**RE: Sundance Construction – Beverly Hills
Conceptual Grading Plan
Engineer's Stamp Date: No Stamp Date
Hydrology File: B18D023**

DRAINAGE AND TRANSPORTATION INFORMATION SHEET (REV 09/2015)

**RE: Sundance Construction – Beverly Hills
Conceptual Grading Plan
Engineers Stamp Date: No Stamp Date
Hydrology File: B18D023**

C-101

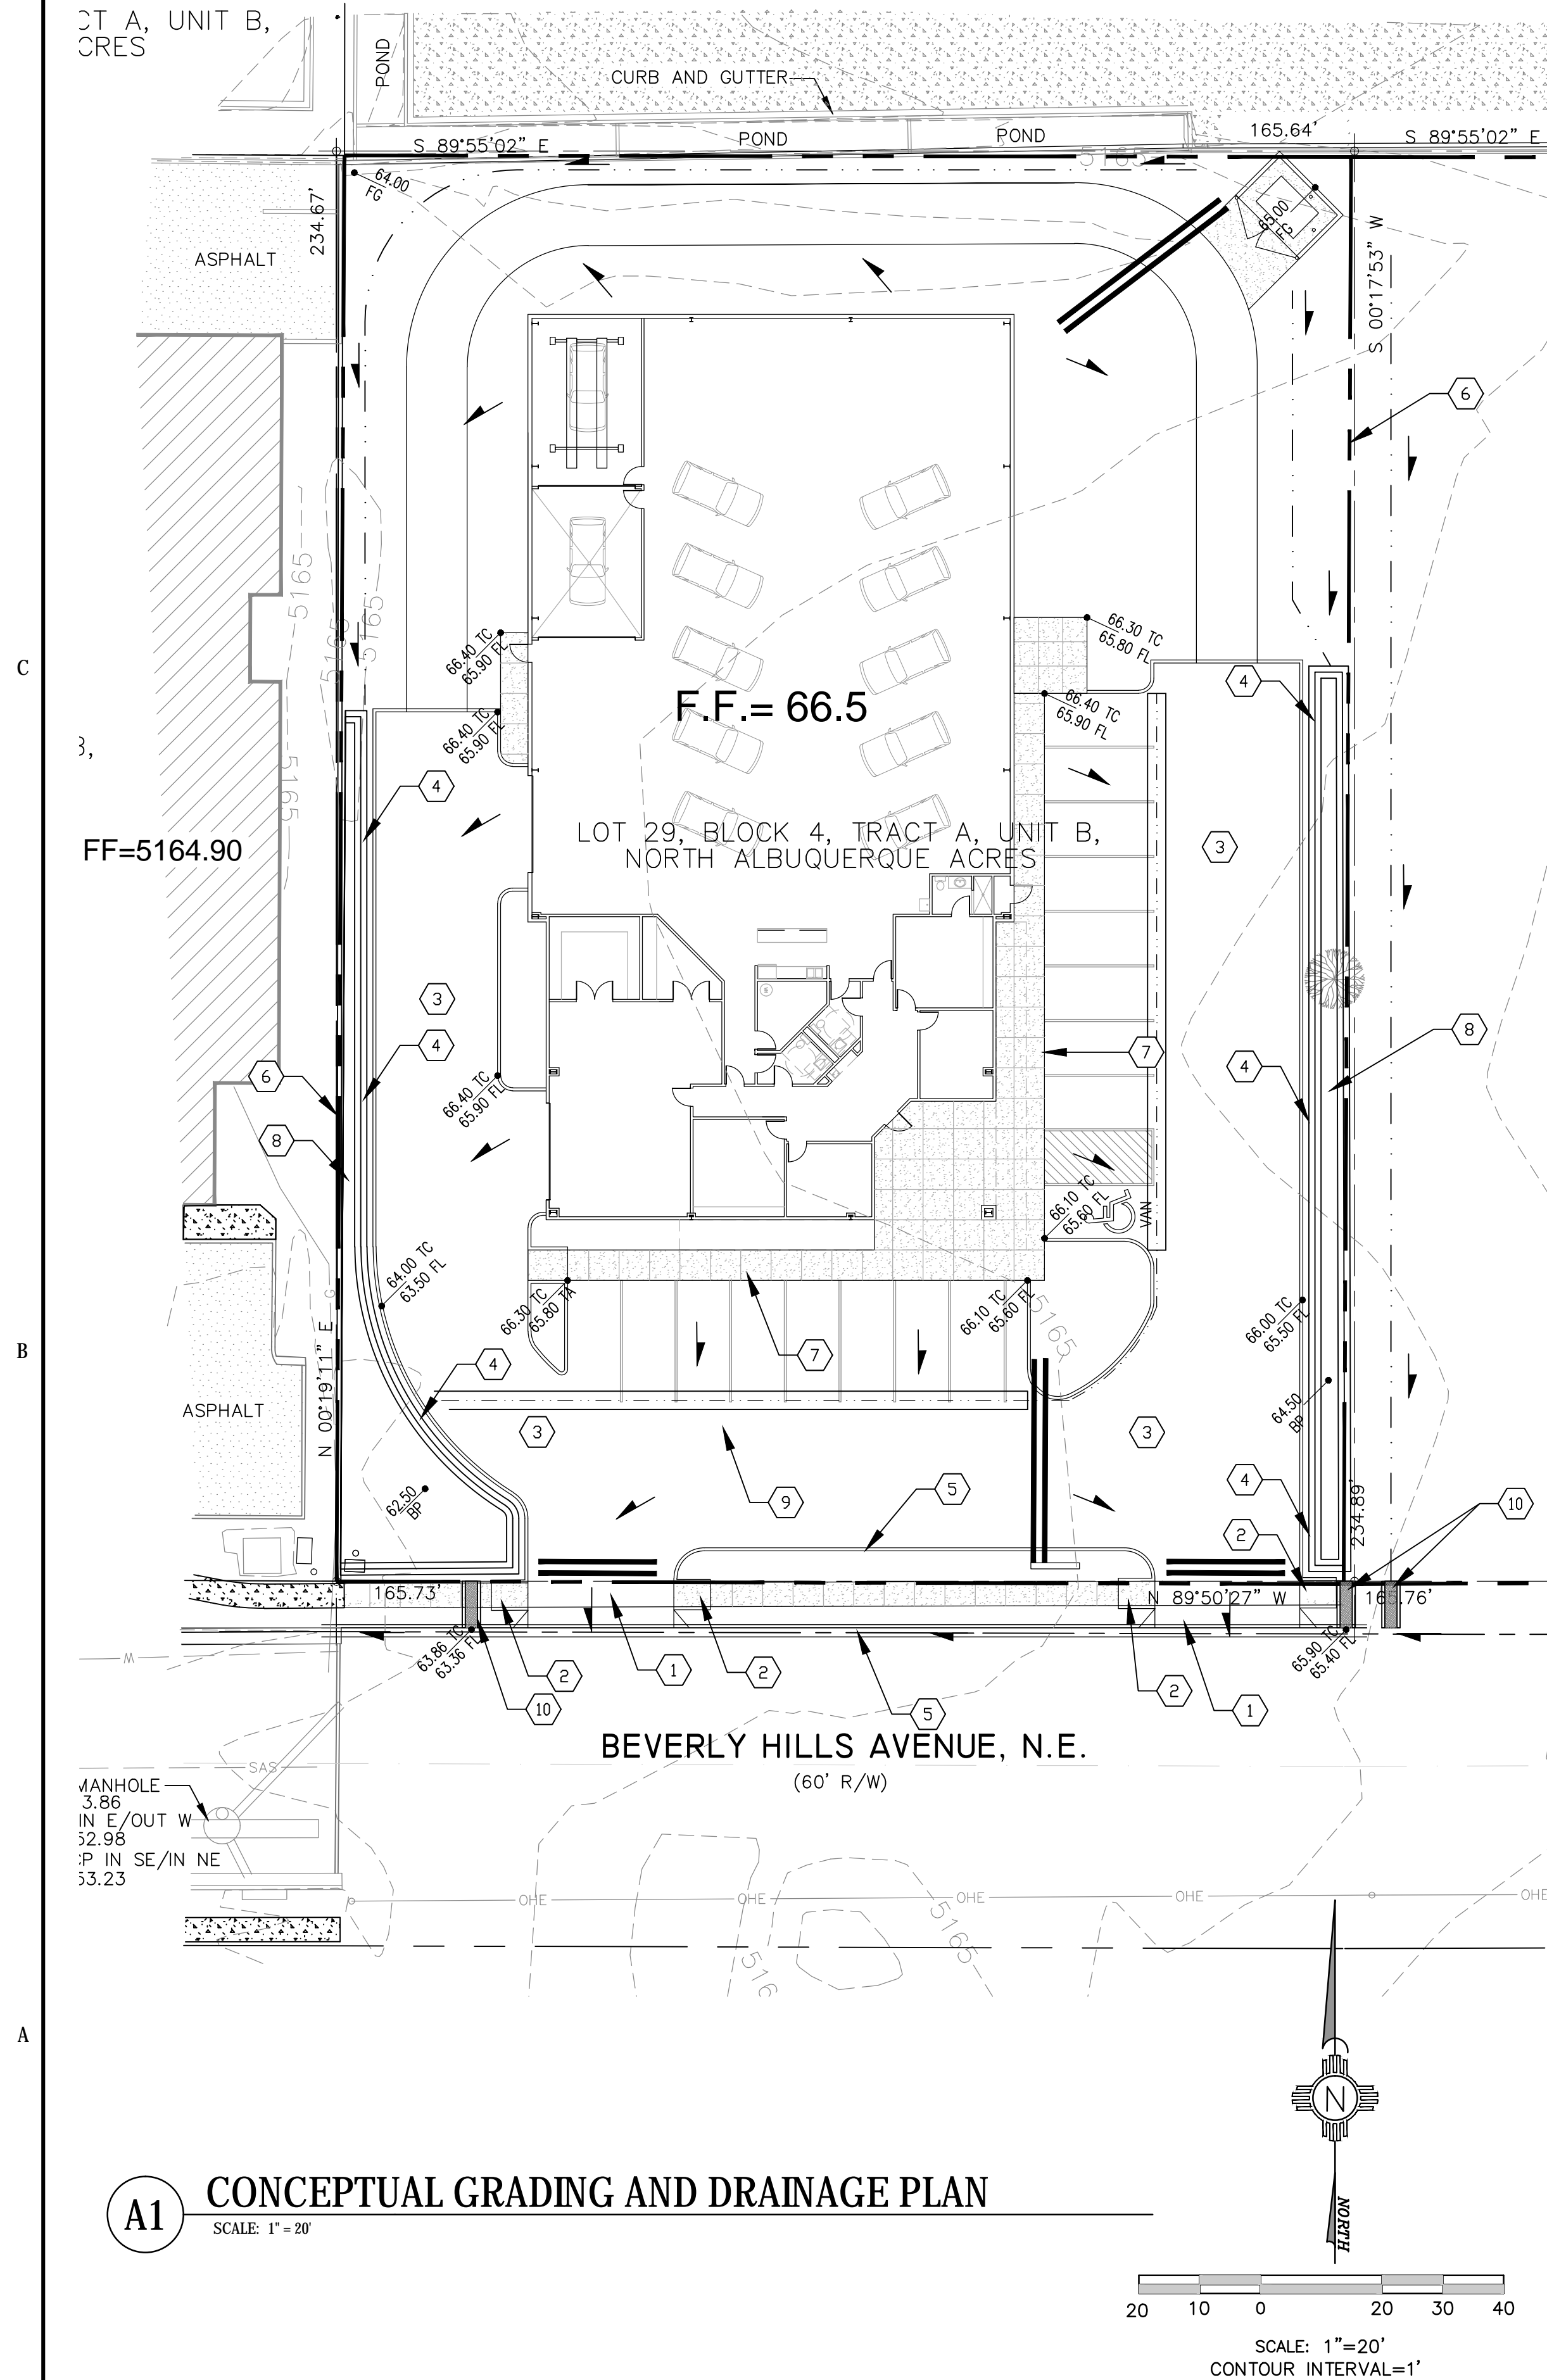
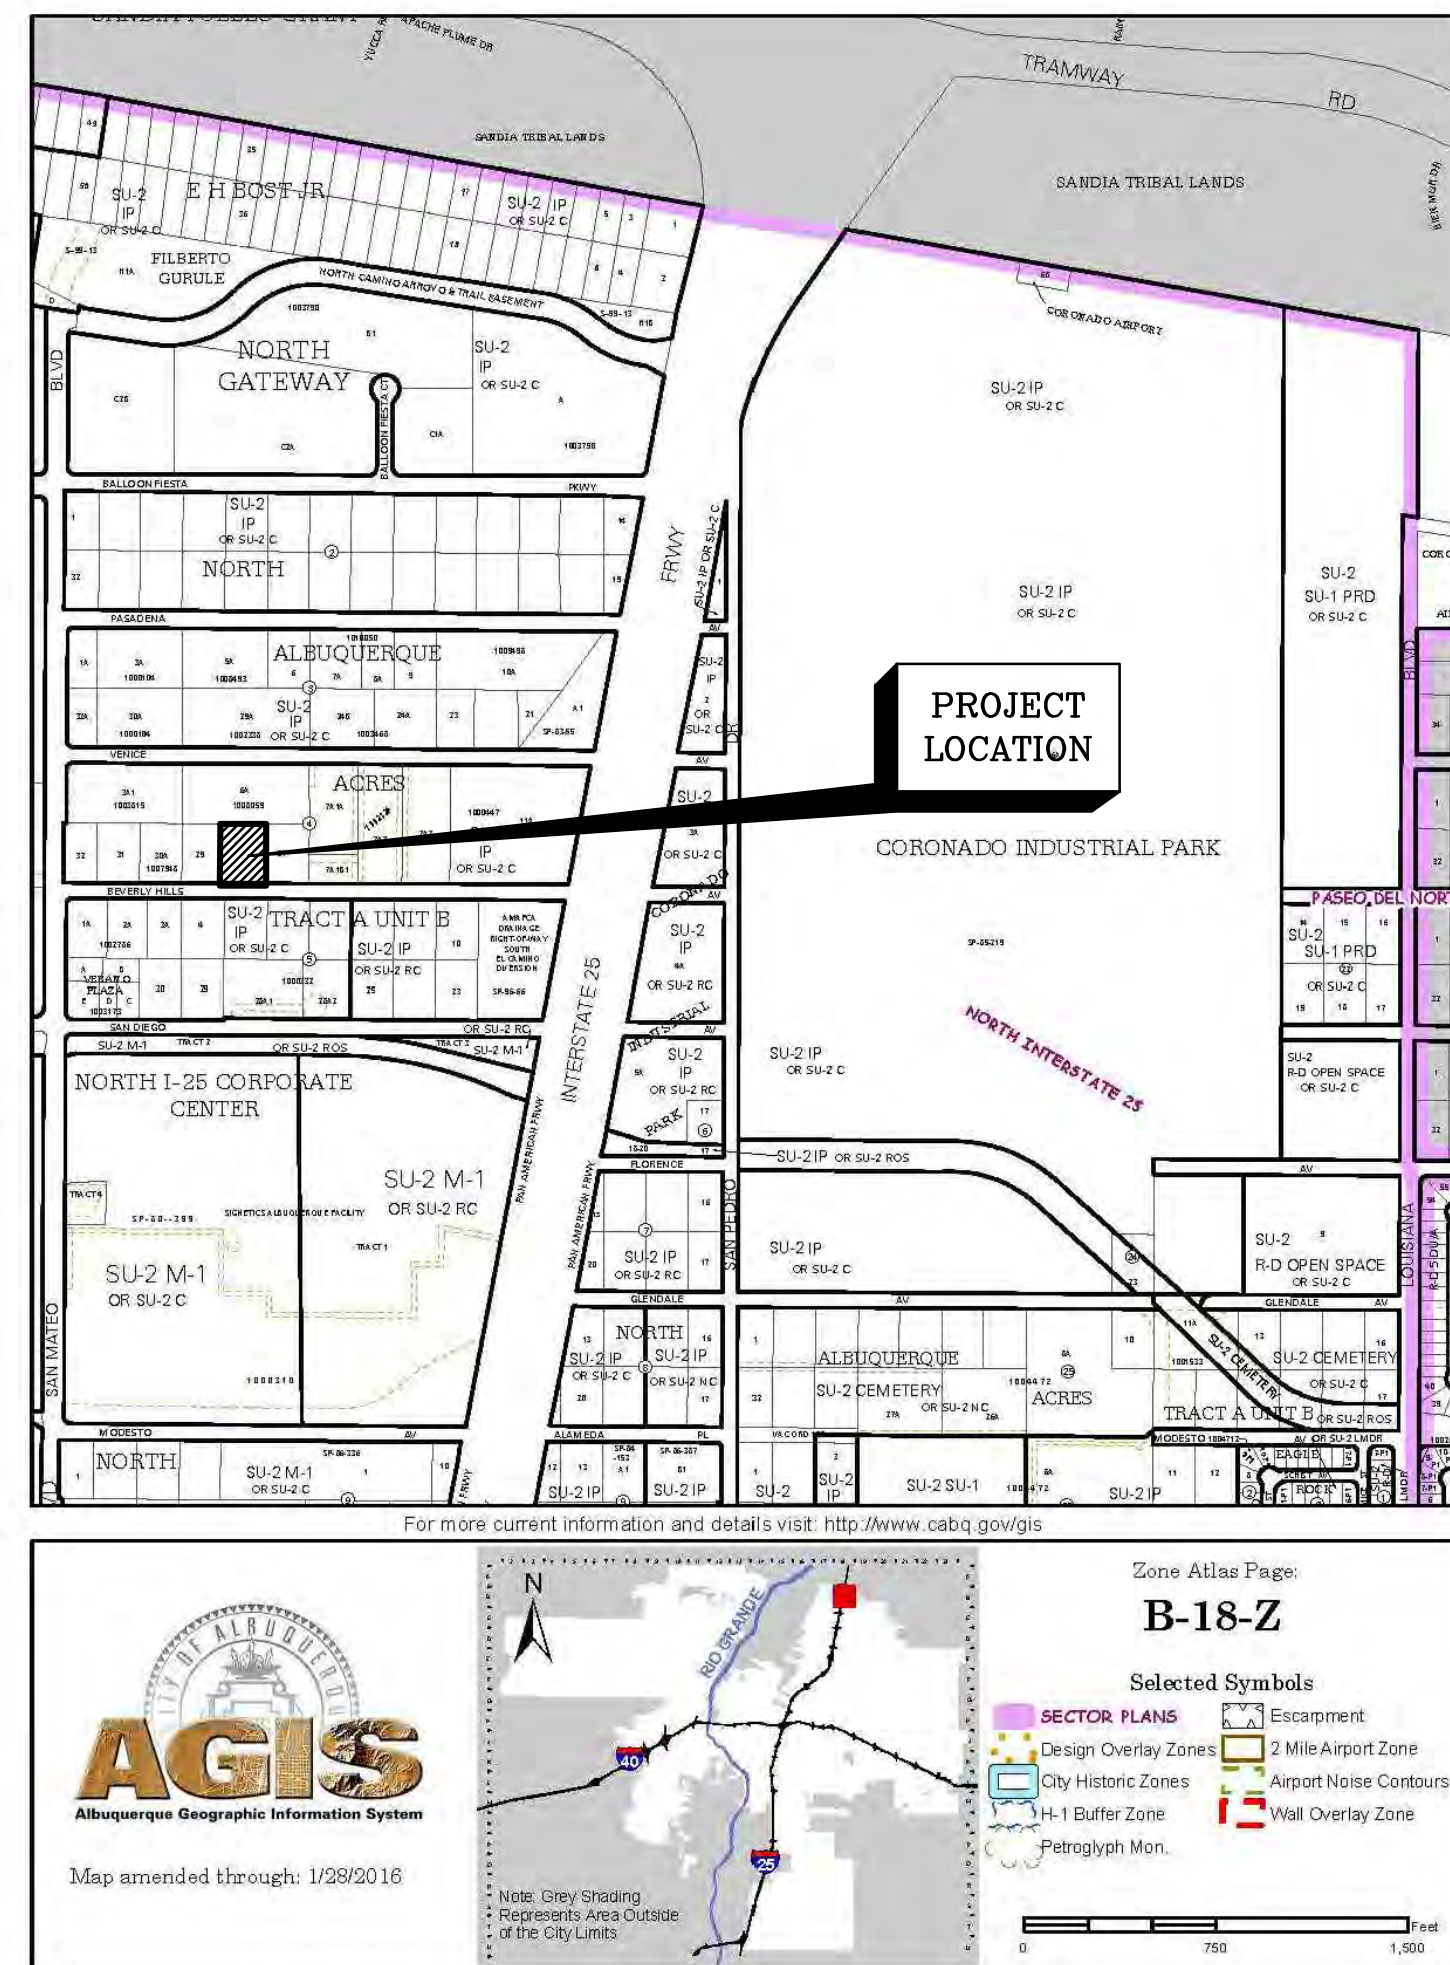
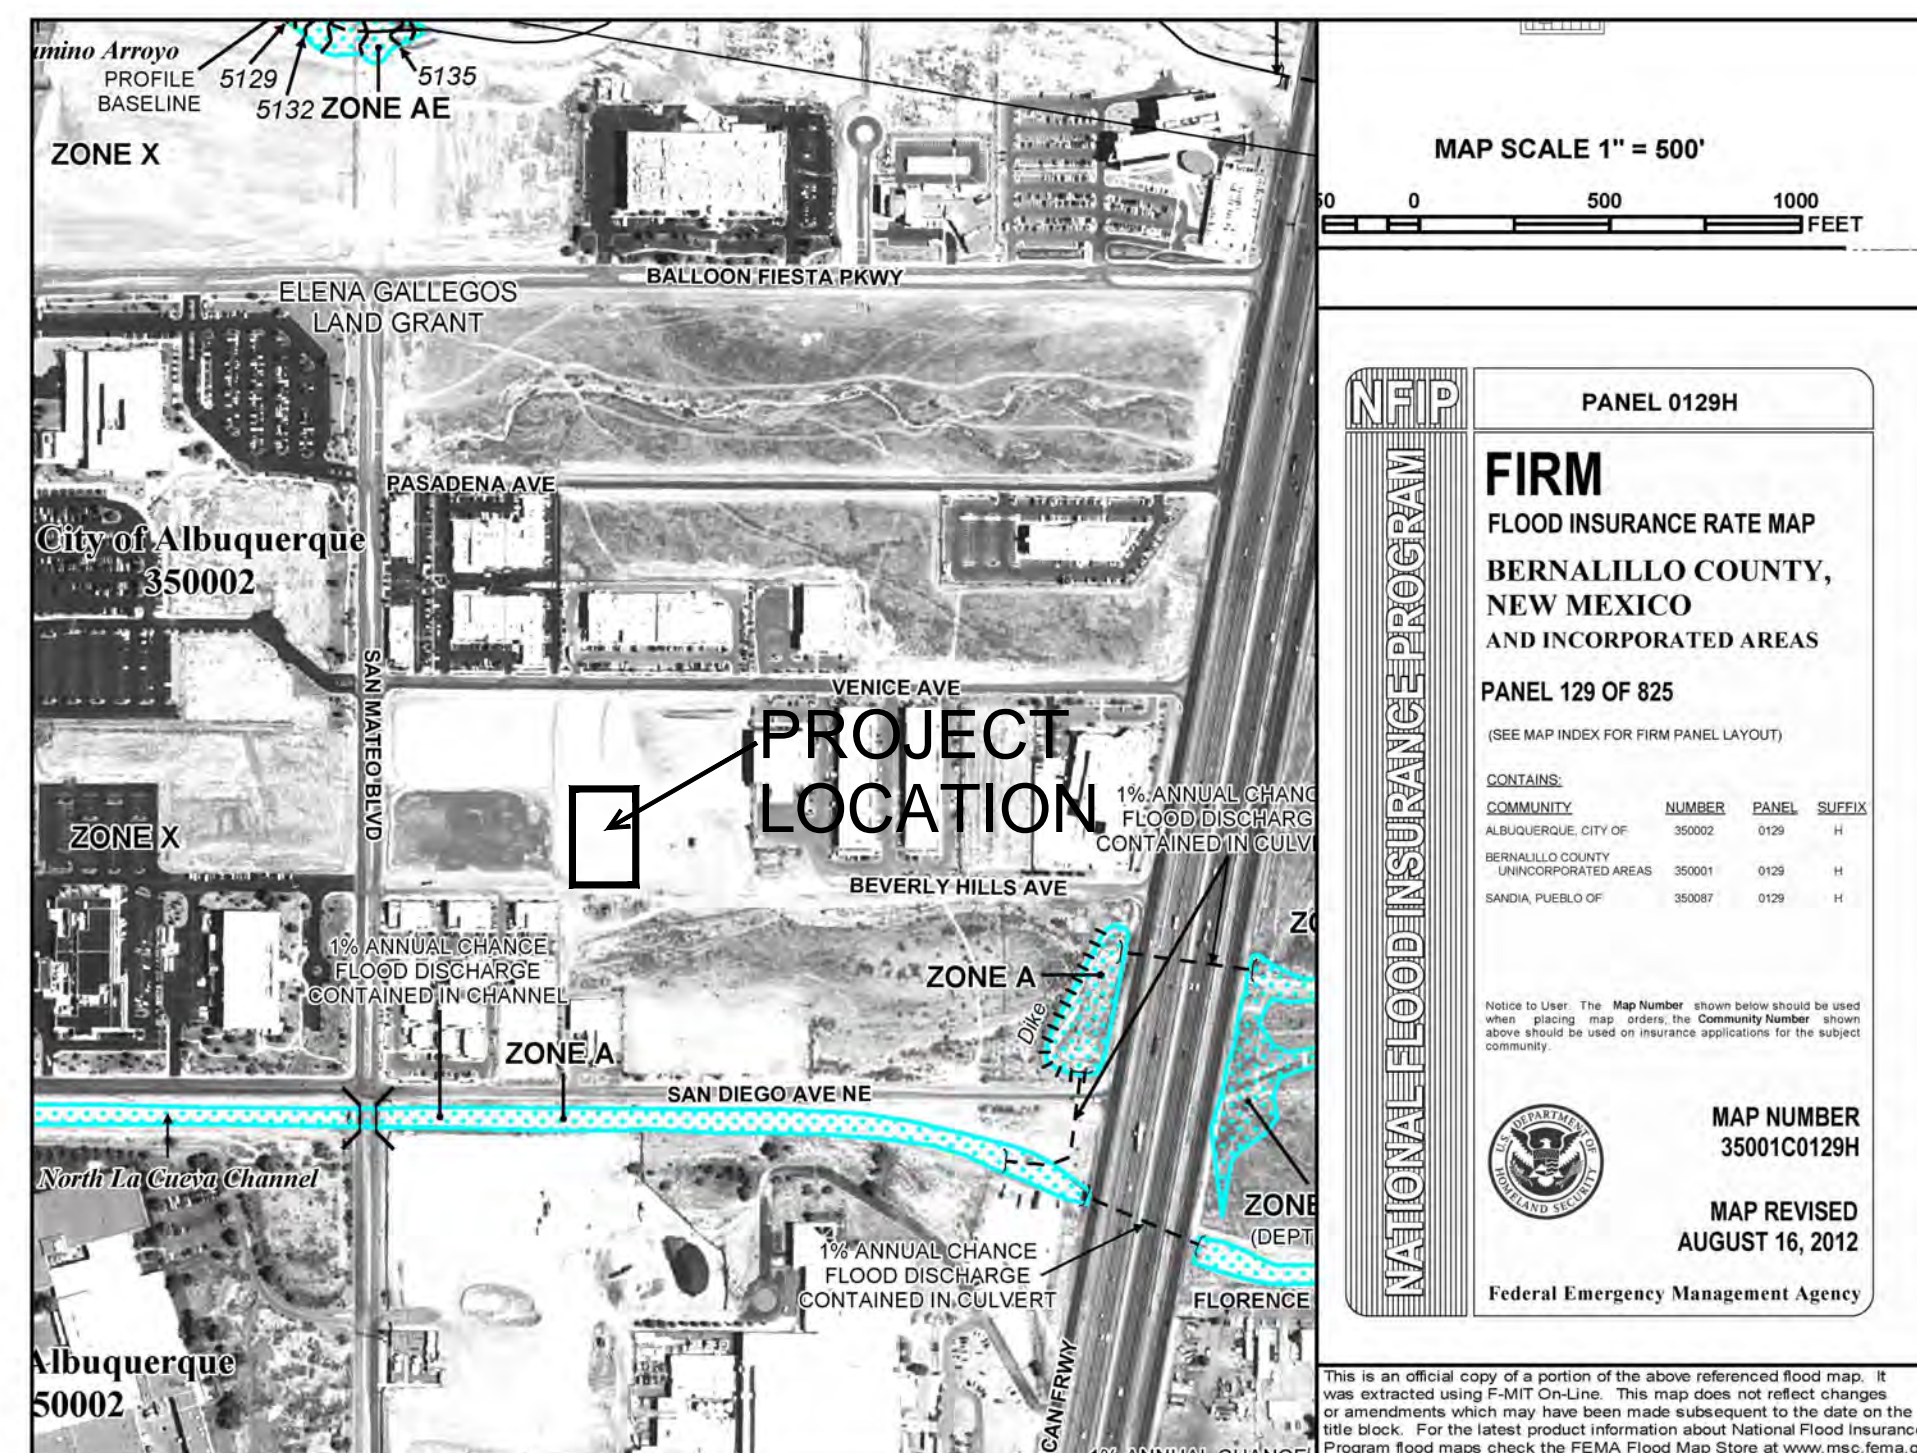
1. Please provide the FIRM-Map and flood plan note with effective date.

2. Please provide a vicinity map showing the location of the site. Typically, this is the Zone Atlas. This can be downloaded in pdf format from the City of Albuquerque's website.

3. Please review the upstream watershed for Beverly Hills Ave. These drainage areas should include all upstream discharges per their ultimate design. Per Chapter 22 Section 3 E (Street Hydraulics) of the DPM, the calculations are for the 10 year and 100 year storm event. The existing 36 inch storm sewer may need to be extended if future inlets are need where the future flows exceeds the street capacity. Also, the existing 18 inch storm sewer may need to be extended to the southwest corner of the tract with a new inlet. If needed, these storm sewer items will have to be included in the Infrastructure List which will be submitted during the DRB action.

See attached revised Conceptual Grading & Drainage Plan.

See attached revised Conceptual Grading & Drainage Plan.

The proposed storm drain system is included in the Infrastructure list which will be submitted as part of the DRB submittal and attached herein. The design for the storm drain system was based on City Project Number 637181 – Beverly Hills Ave & Venice Ave Office/Warehouse project by Isaacson & Arfman, P.A. (stamped by Fred Arfman PE #

7322 on 8/14/2000 and approved by the City Engineer in August 2000). These plans show a future 36" RCP crossing the frontage of Lot 29 with future curb inlets placed on the north side of Beverly Hills Ave. just east of the west property line of Lot 29 and just west of the east property line of lot 30 (already installed). These plans also have Q's for the proposed storm drain system. See attached plans

The 36" existing storm drain that has been constructed west of our site (Lot 29) is a 36" RCP. There is an existing Manhole just west of Lot 29 with a 36" RCP stubbed out just past the end of the existing pavement at the west property line of our site. This existing storm drain system is based on Project No. 722081 Beverly Hills Ave Paving and Utility Improvements project by Advanced Engineering and Consulting, LLC (stamped by Shahab Biazar PE # 13479 on 8/25/2005 and approved by the City Engineer in Dec. 2004). These plans show a future 36" RCP stub to the west property line Lot 29. These plans also have Q's for the proposed storm drain system that match the Q's on the plans mentioned above by Fred Arfman. See Attached plans.
